**• A D D E N D U M # 2 •**

<b>TO ALL PLAN HOLDERS</b>	<b>DATE</b>	<b>JULY 10, 2015</b>	<b>JOB NO.:</b>	<b>2302-023</b>
	<b>ATTN</b>	<b>Plan Holders</b>		
	<b>RE</b>	<b>City of Newport Ferry Slip Road Improvements</b>

UTILITY PLAN STA 0+00 TO 4+50  
1" = 40'

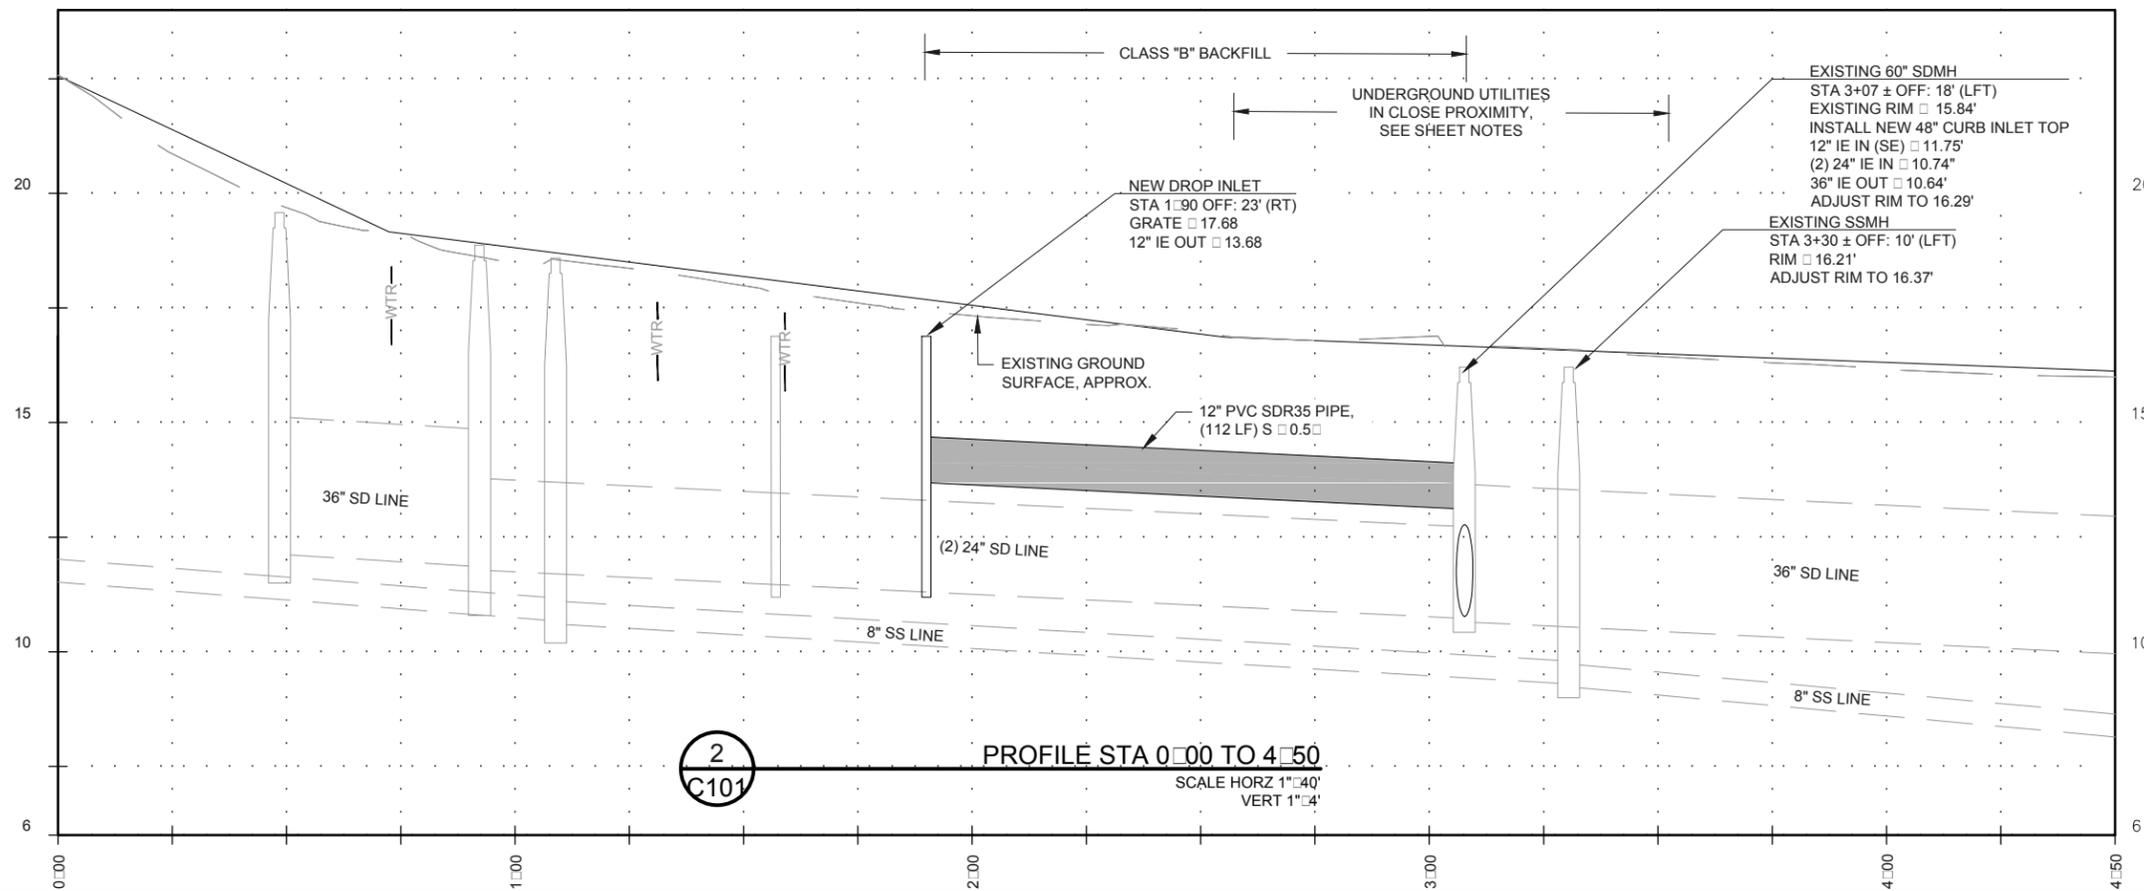
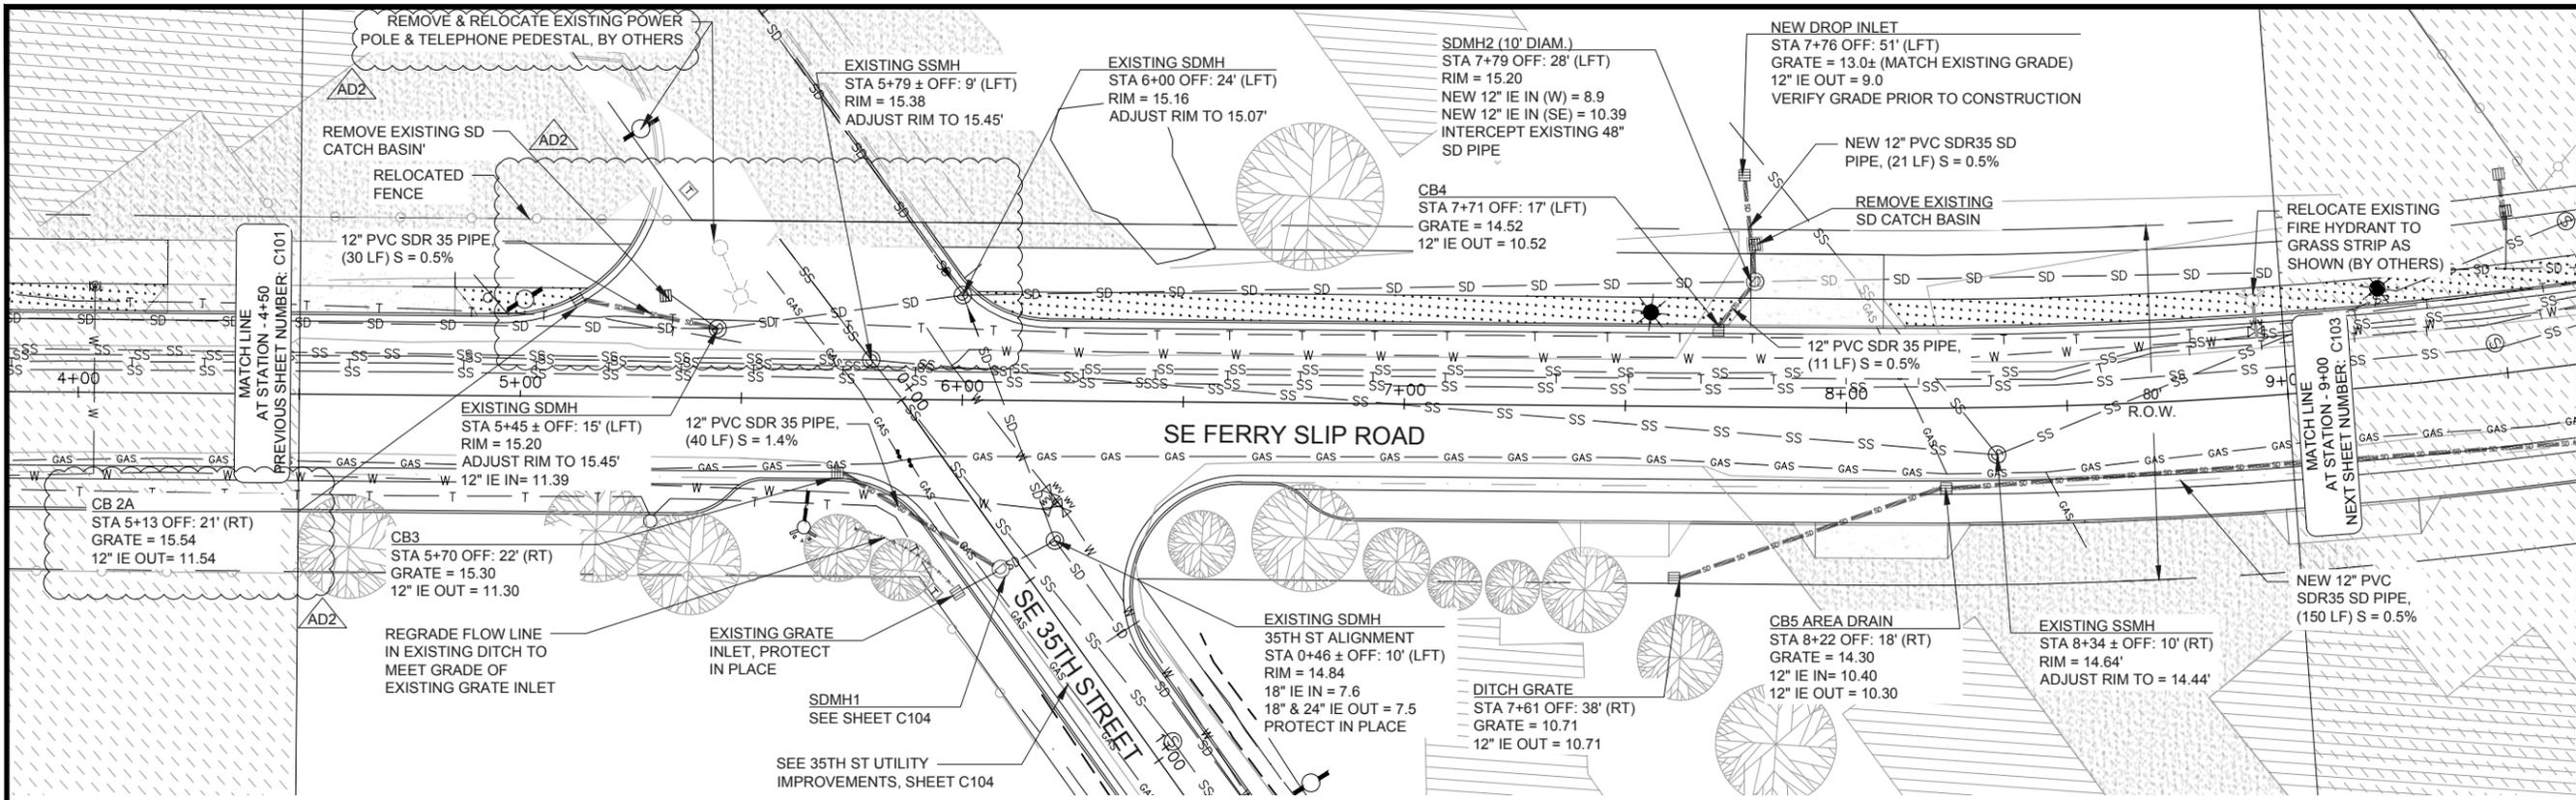
15. C004- Delete "END 2" GRIND" from "Sta 3+46 offset 18' rt..." callout.
16. C101- Add 5' AC pathway from Sta 0+00 to Sta 0+60.
17. C101/C201/C202- Increase driveway size to 75' and move to Sta 4+52.

1  
C102  
UTILITY PLAN STA 4+50 TO 9+00  
1" = 40'

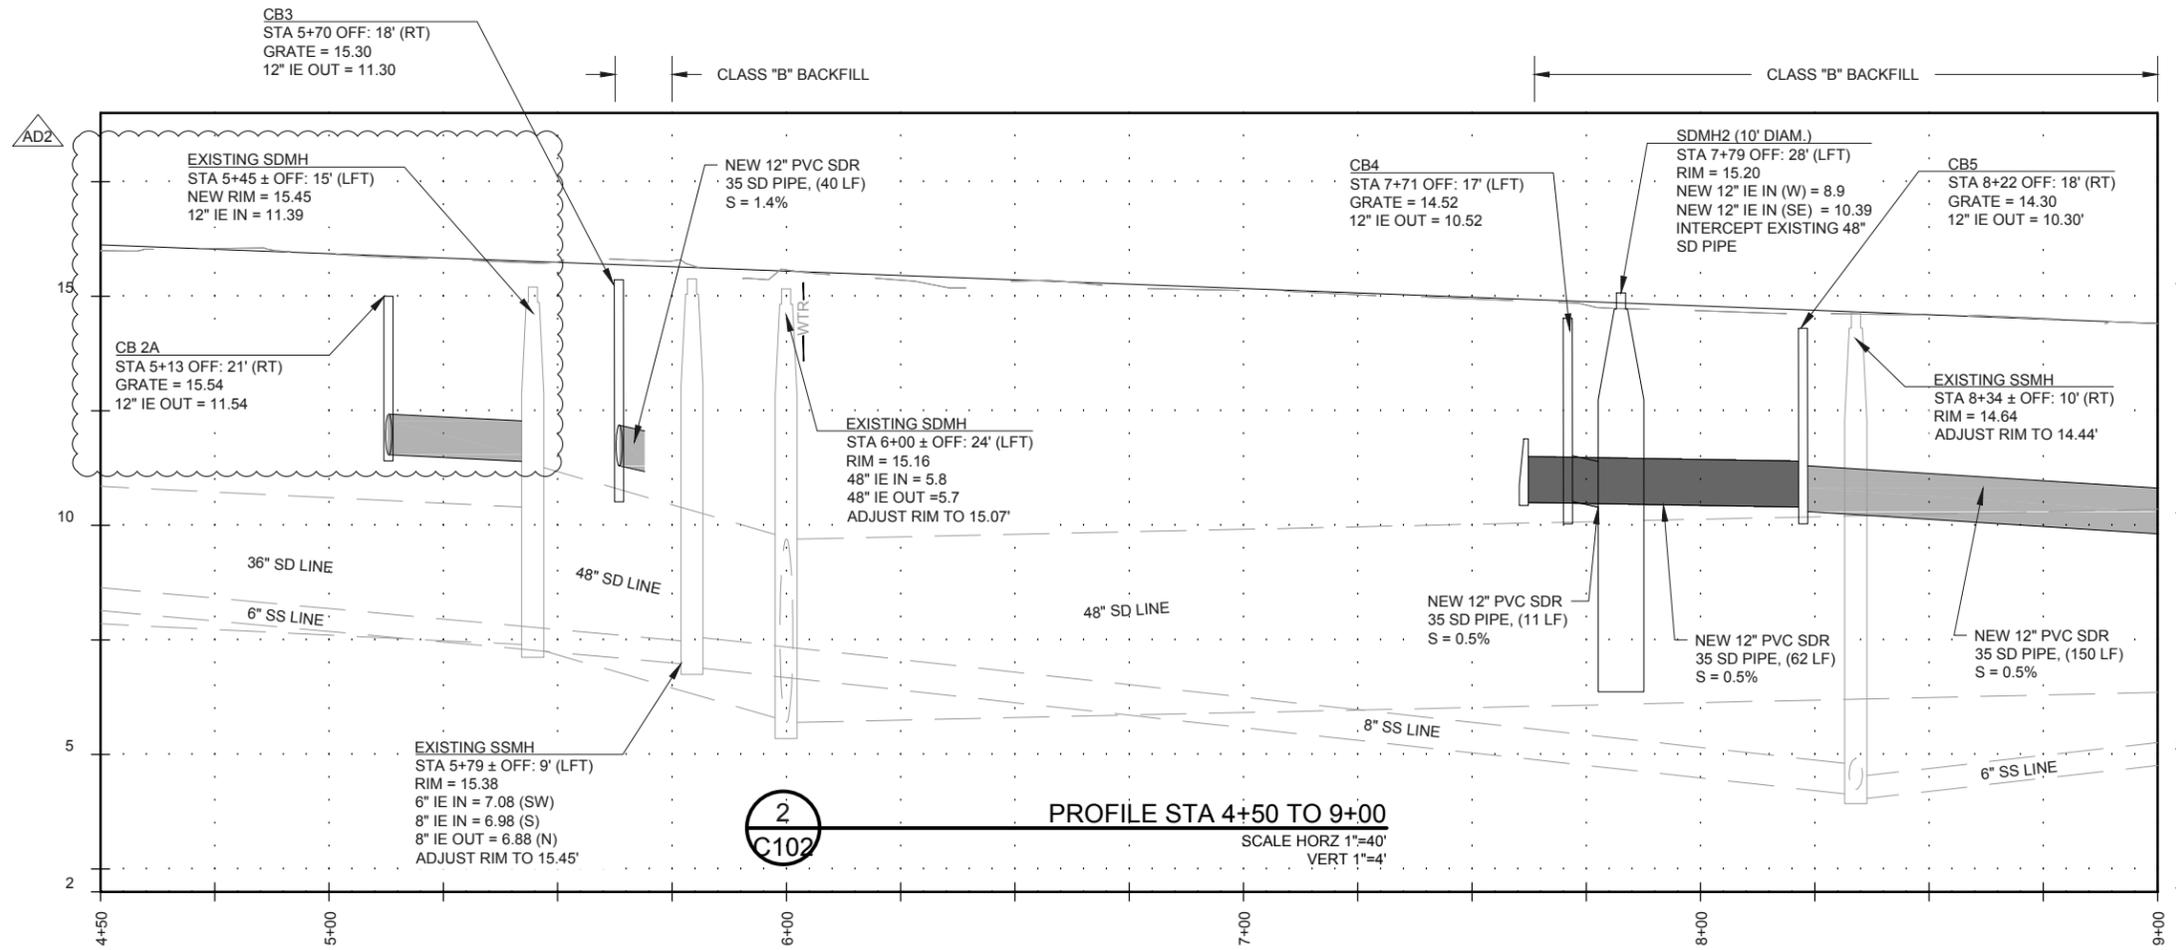
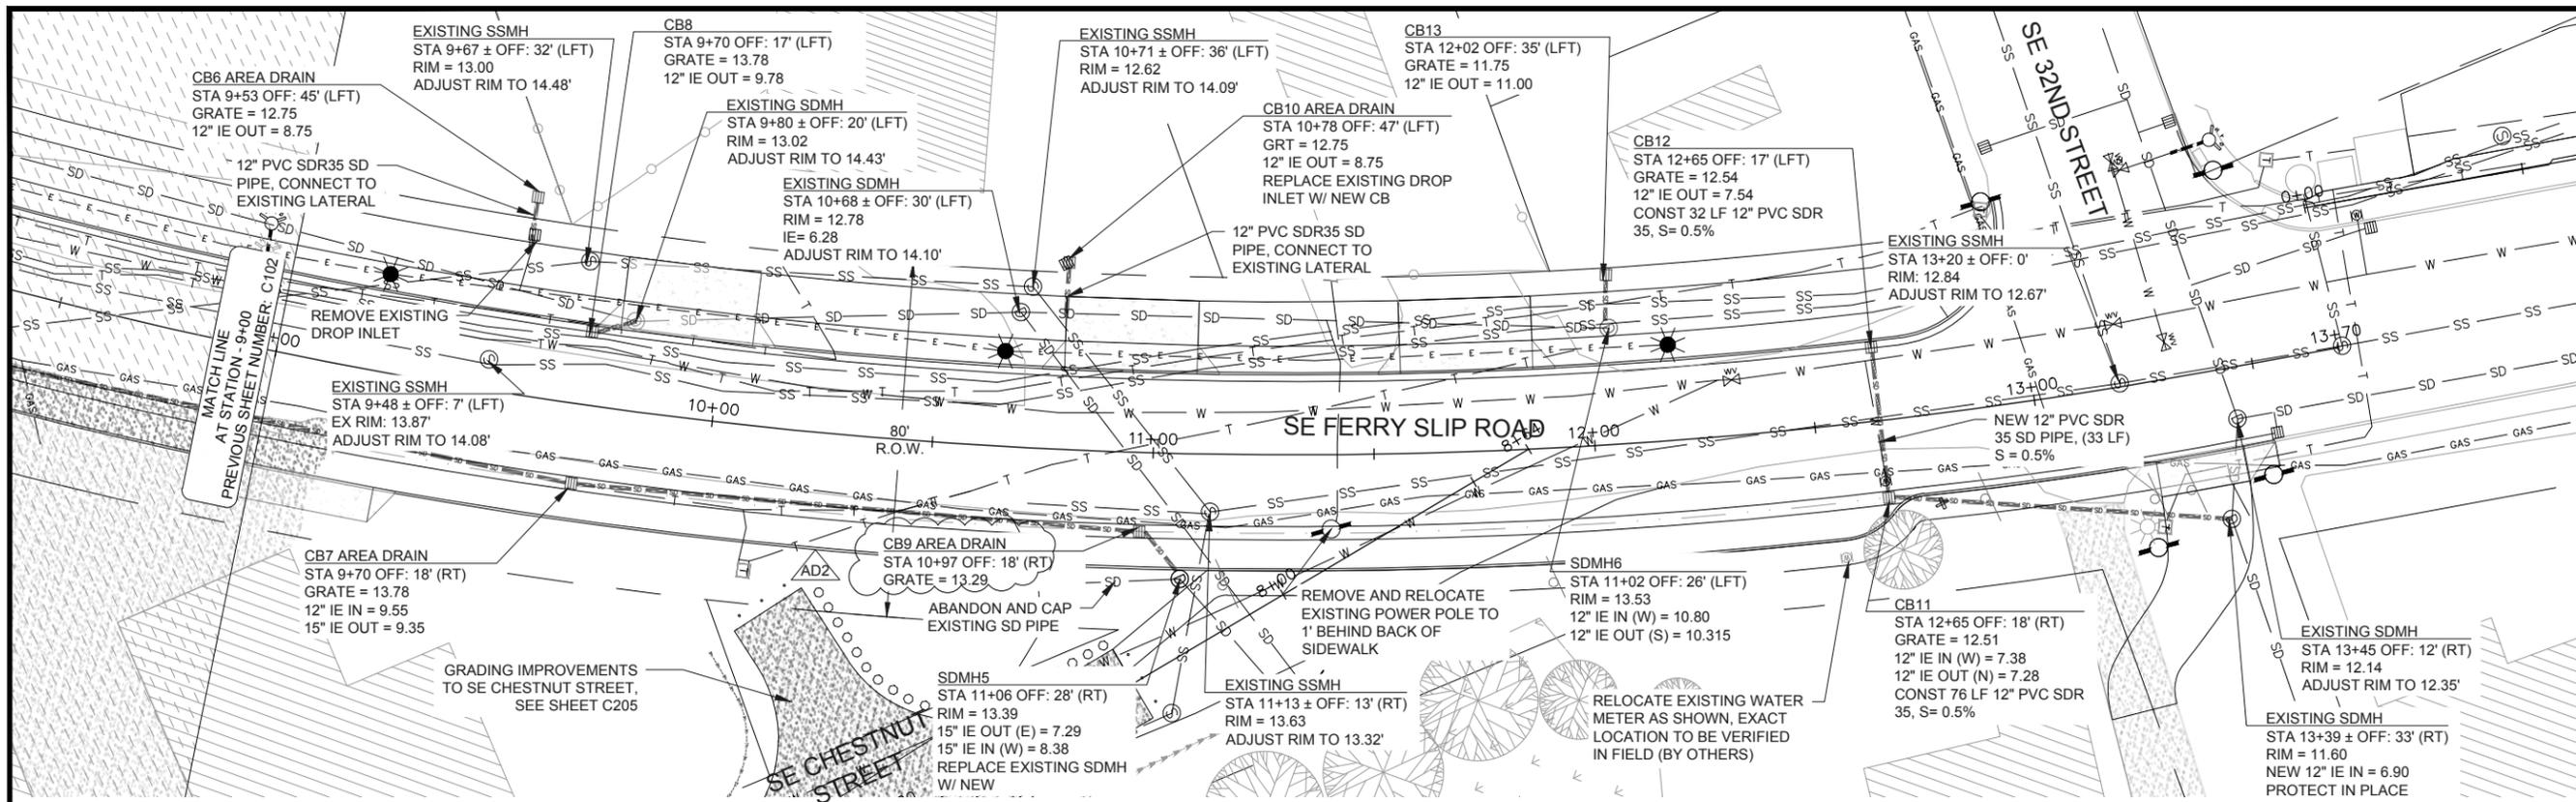
18. C102/C202- Extend curb and overlay at the intersection of SE 35<sup>th</sup> and Ferry Slip Rd (West Side).
19. C102- Add "BY OTHERS" to "remove and relocate existing power..." callout.
